North East Albion Concept Plan

Date: Wednesday, June 22, 2022 at 08:10 a.m. PDT

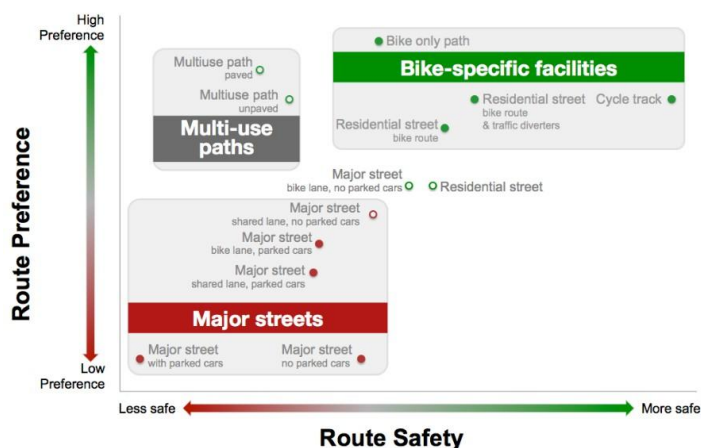
It's important to keep the bike lanes. Both 248 St. and 112 Ave. are arterial roads and part of the primary cycling network. People need access on both sides of the road to cycling infra (we don't want people crossing the road mid-block to access the MUP), and as we know it's much safer to have uni-directional infrastructure at unsignalized intersections and driveways. We also know that MUPs are not as safe as people think, as research has shown. Again, this is shown by this graph from UBC Cycling in Cities research:

This research was done a number of years ago, when e-bikes weren't quite as common as they are now, and growth in use will continue to grow. Most certainly the case that can be made for separation of micromobilities and pedestrians is now even stronger.
